U S NAVY RESPONSES TO U S EPA REGION I AND RHODE ISLAND DEPARTMENT OF  
ENVIRONMENTAL MANAGEMENT COMMENTS ON DRAFT RECORD OF DECISION SITE 7  
TANK FARM 1 DECISION UNITS 1-1, 1-2 ( DU 1-1, DU 1-2) AND OPERABLE UNIT 13 ( OU  
13) NS NEWPORT RI  
05/13/2016  
RESOLUTION CONSULTANTS

Navy Responses to Regulatory Agency Comments  
EPA Comments, April 15, 2016  
RIDEM Comments, April 28, 2016

Draft Record of Decision,  
Site 7 – Tank Farm 1, Decision Units 1-1, 1-2, and 1-3 (Operable Unit 13)  
Naval Station Newport, Portsmouth, Rhode Island

May 13, 2016

**FIGURE 3**  
 SELECTED SOIL REMEDIATION FOR  
 DECISION UNIT 1-1  
 RECORD OF DECISION  
 TANK FARM 1 (SITE 7)  
 DECISION UNITS 1-1, 1-2, 1-3  
 NAVSTA NEWPORT, RHODE ISLAND

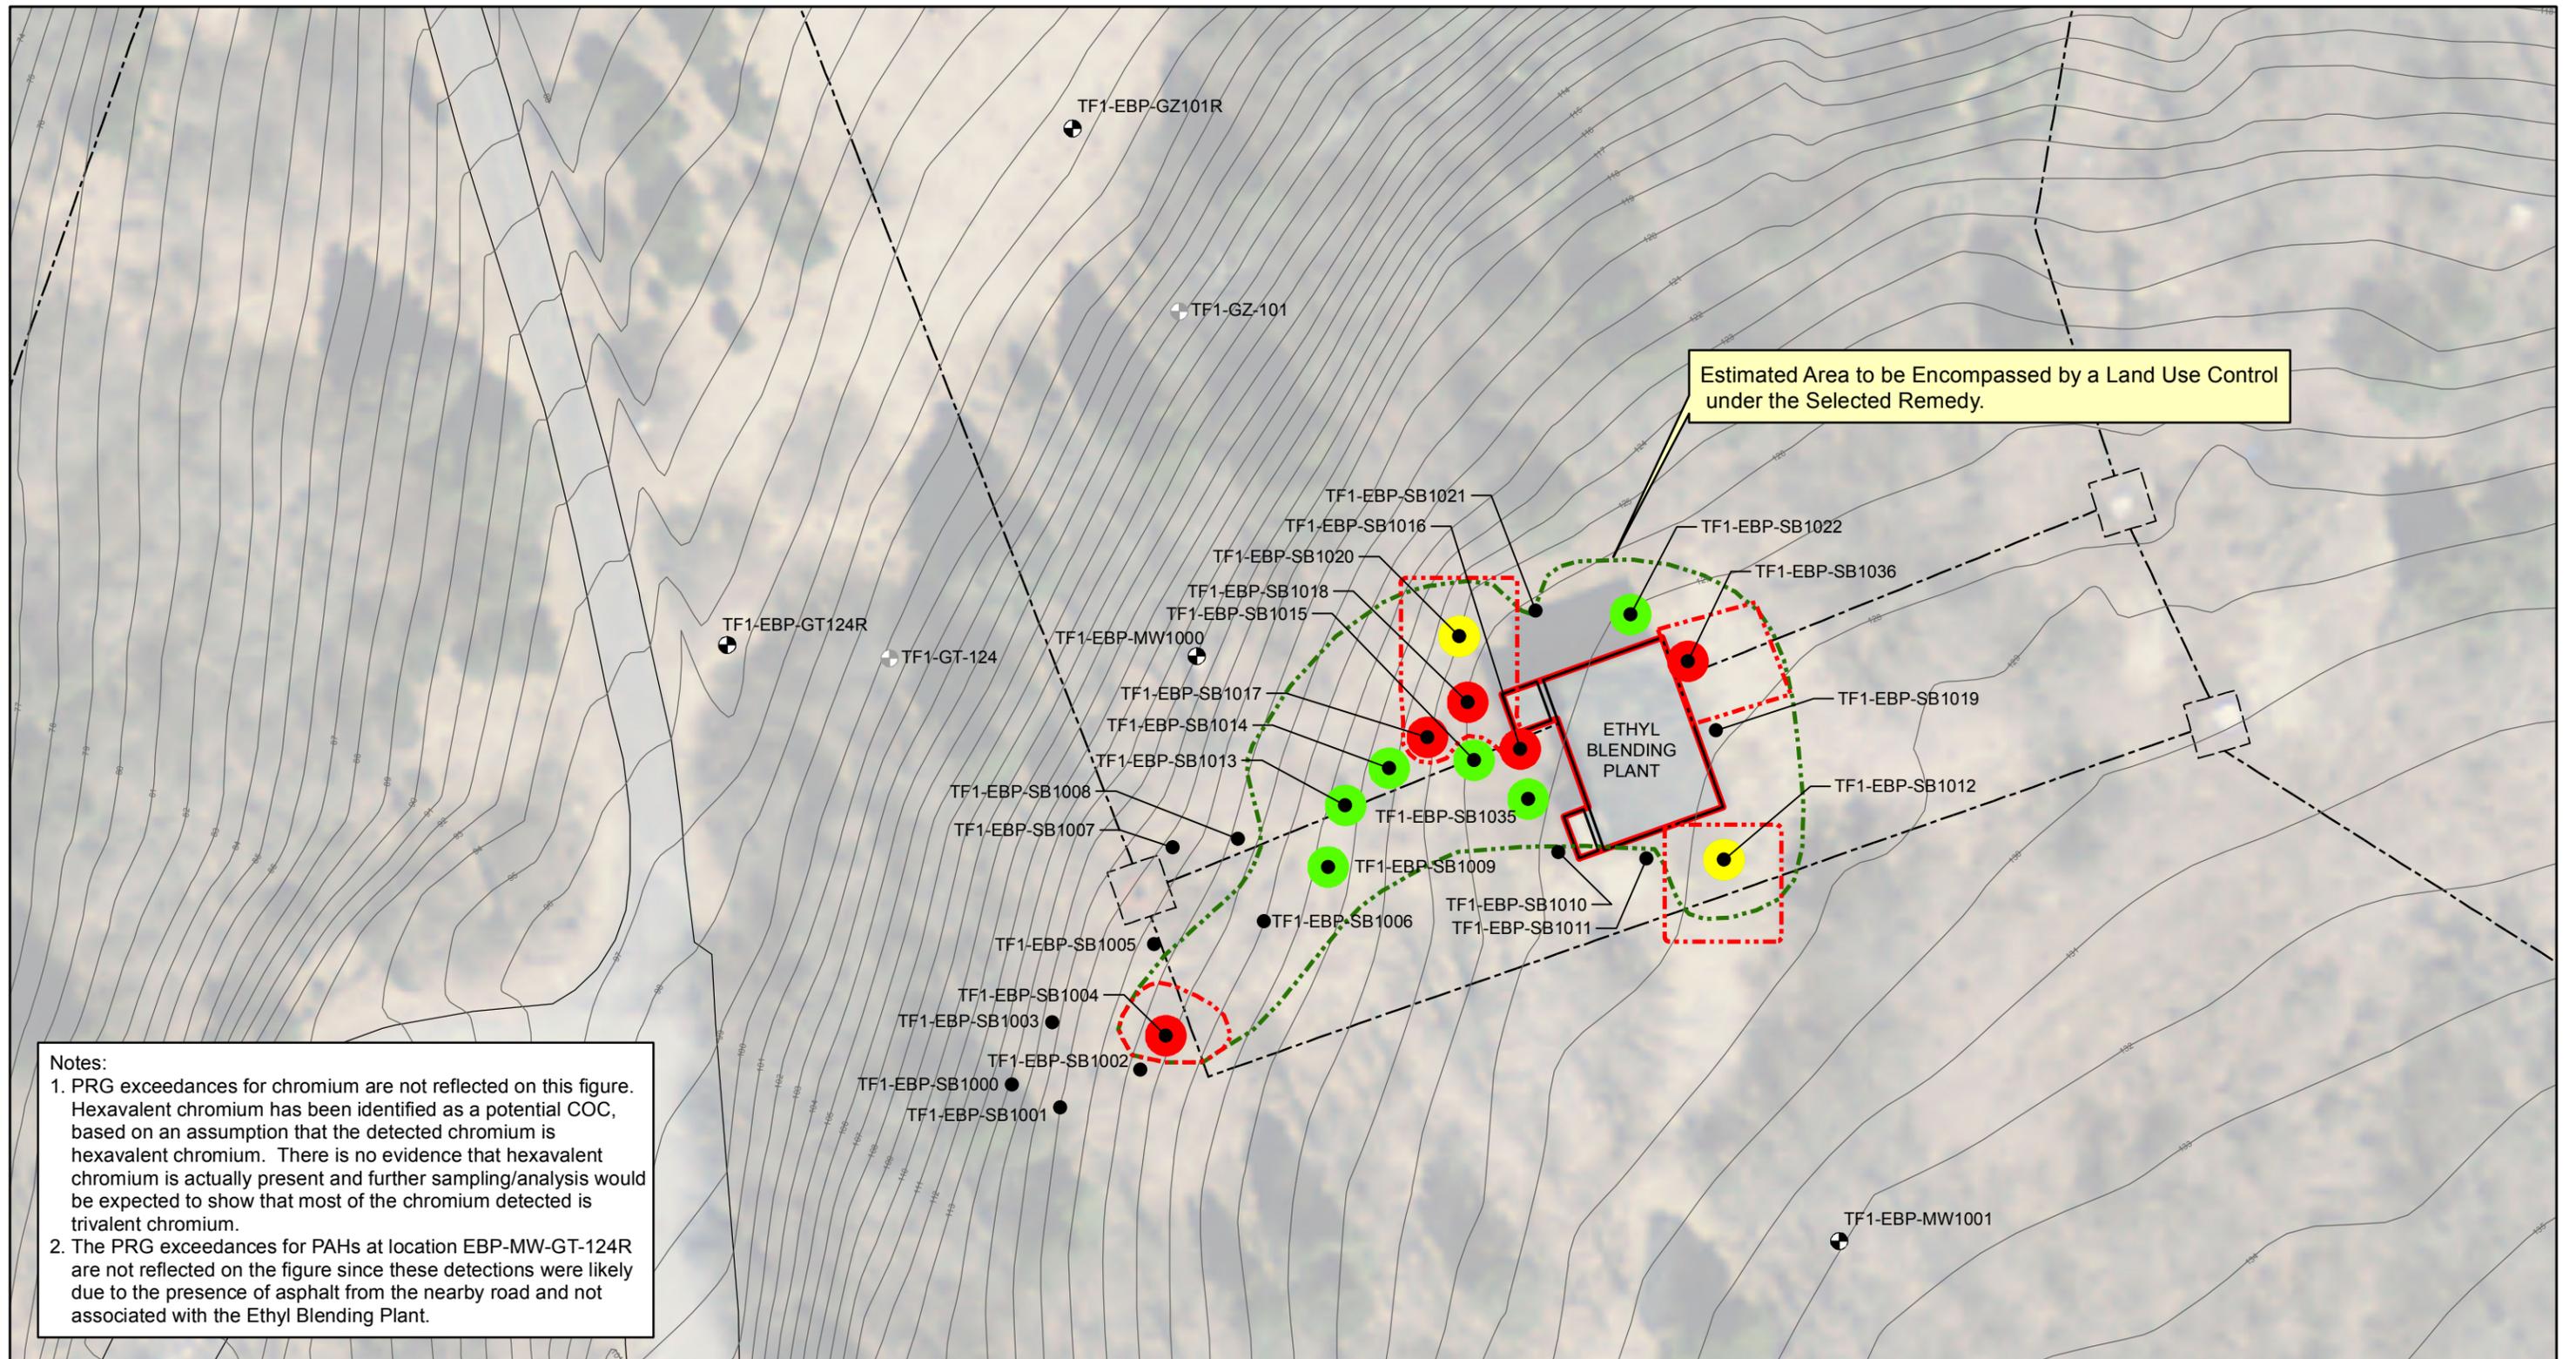
*RIDEM Specific Comment 18. Figures 3, 4 and 5 – These figures depict the limits of excavation as well as long-term LUCs. Please consider also depicting the limits for short-term LUCs around the existing structures.*

Response: The requested changes will be made. See attached revised figures.

**FIGURE 4**  
 SELECTED SOIL REMEDY  
 DECISION UNIT 1-2  
 RECORD OF DECISION  
 TANK FARM 1 - SITE 7  
 DECISION UNITS 1-1, 1-2, 1-3  
 NAVSTA NEWPORT, RHODE ISLAND

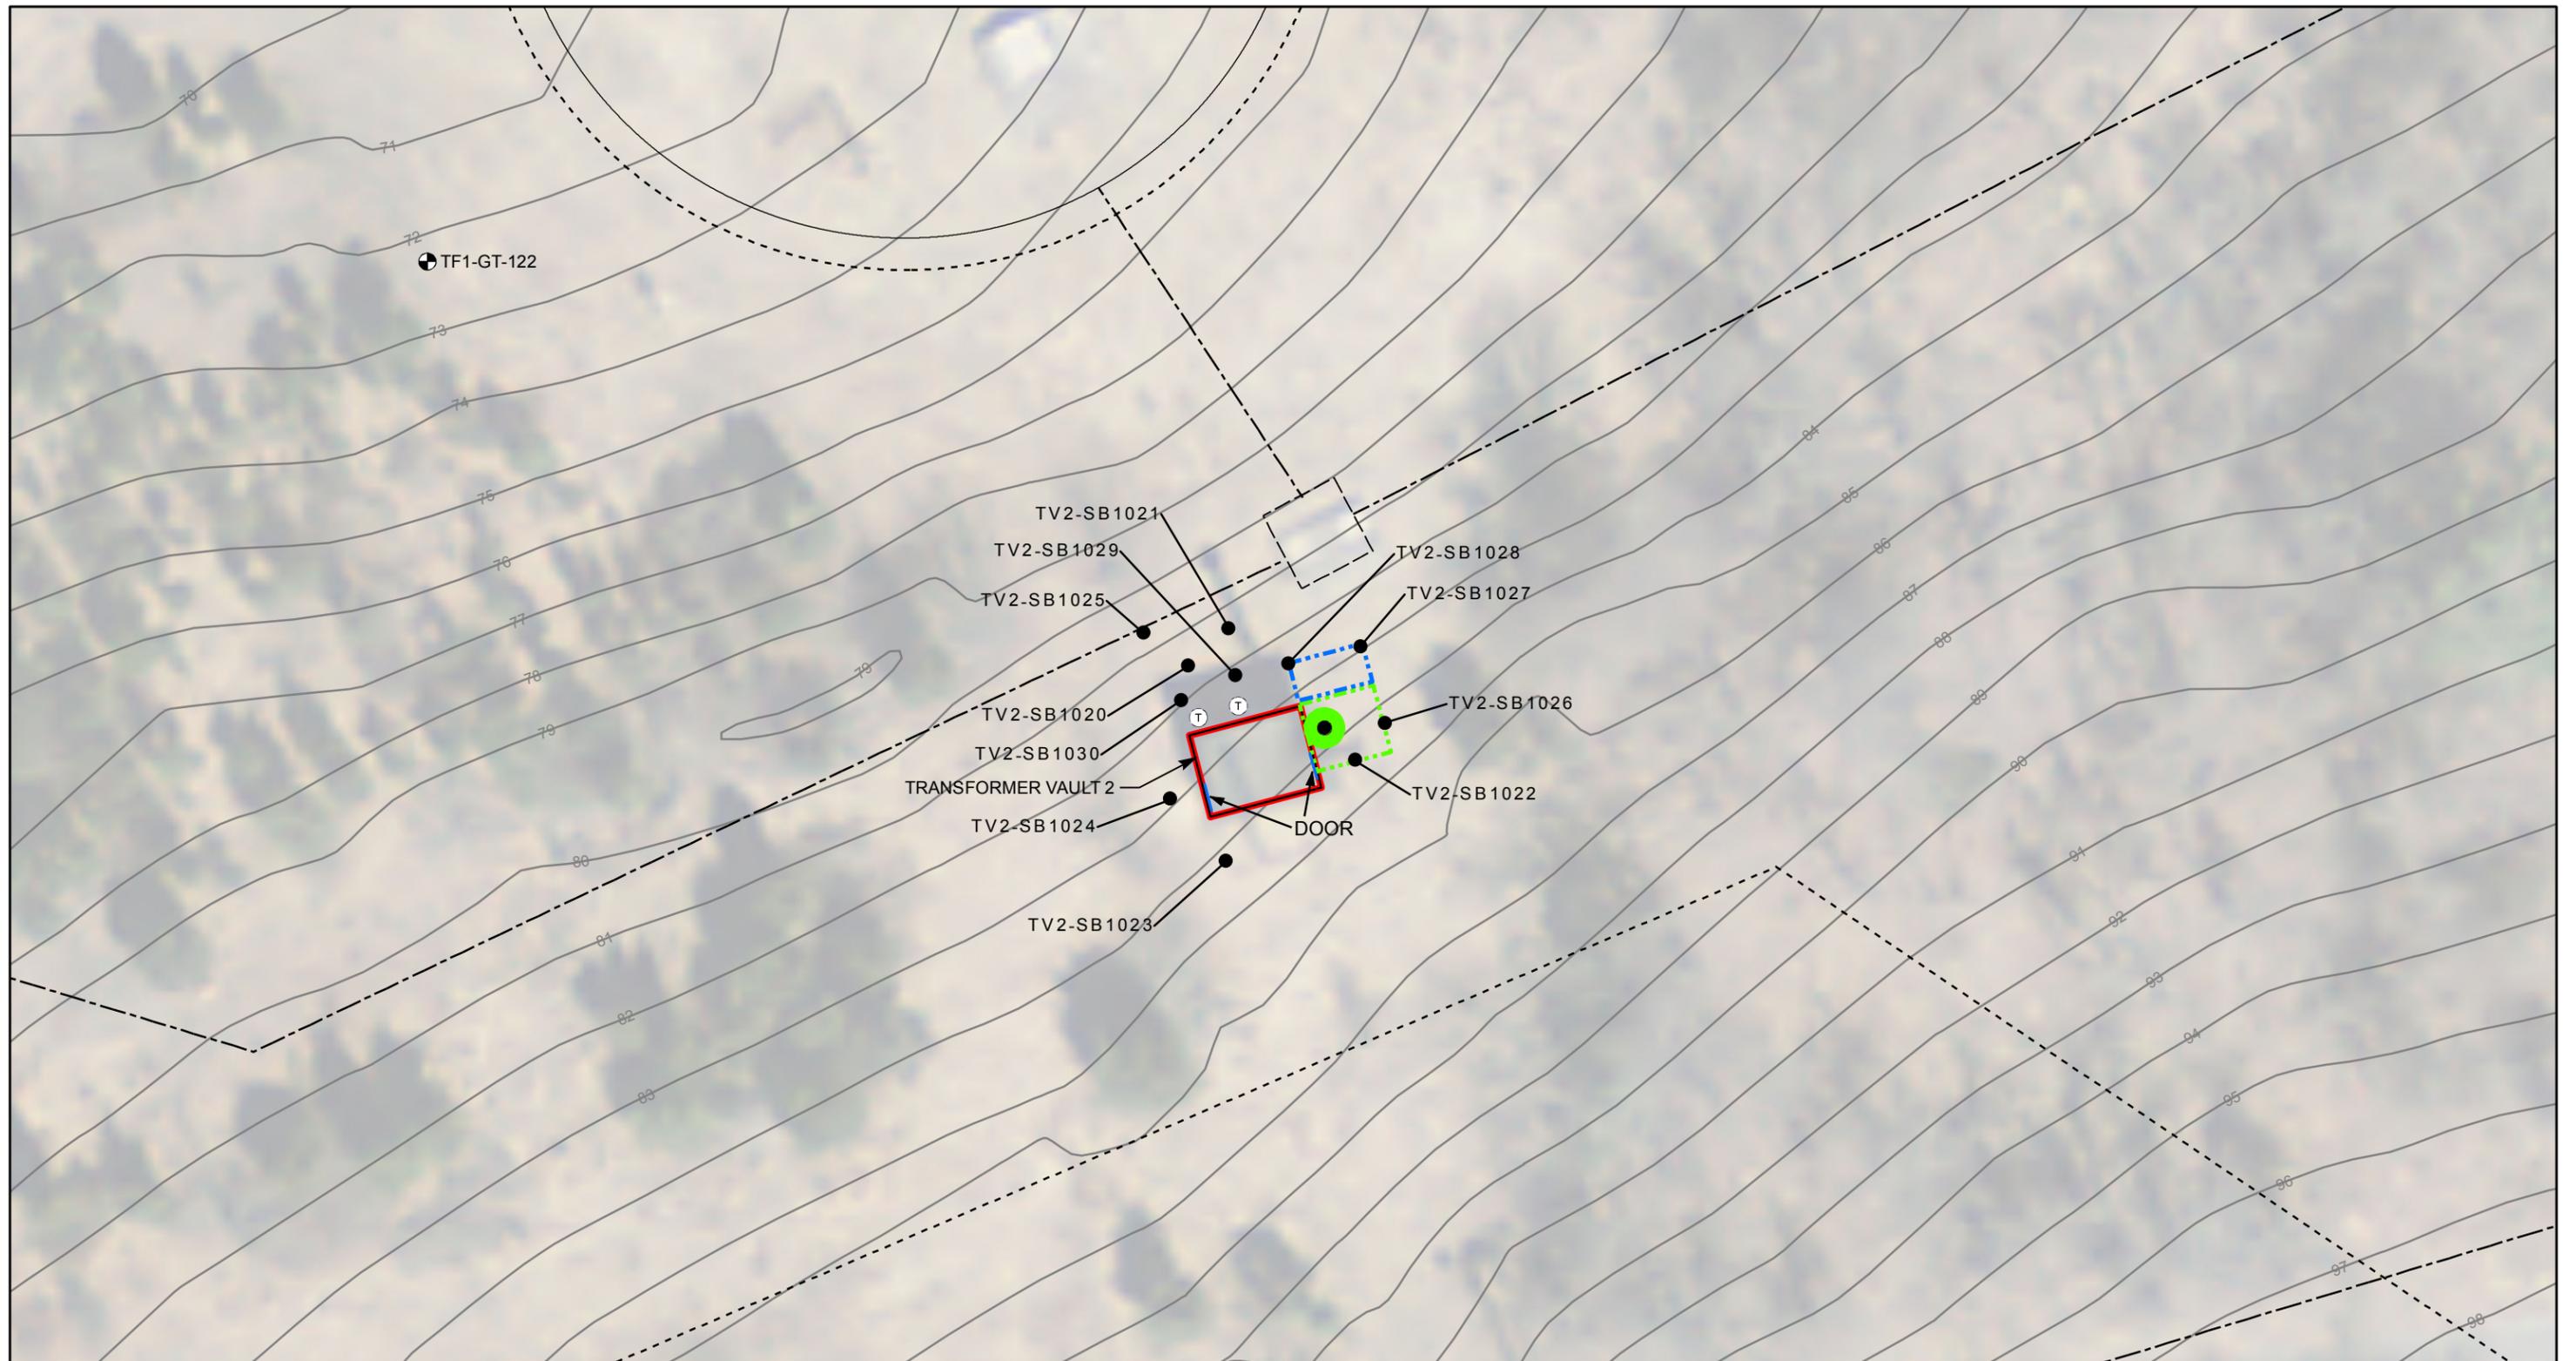
*EPA Specific Comment 29: Fig 4 & 5 – Show the boundary of the LUC areas.*

Response: The figures have been updated to show the LUC area boundaries and are attached.
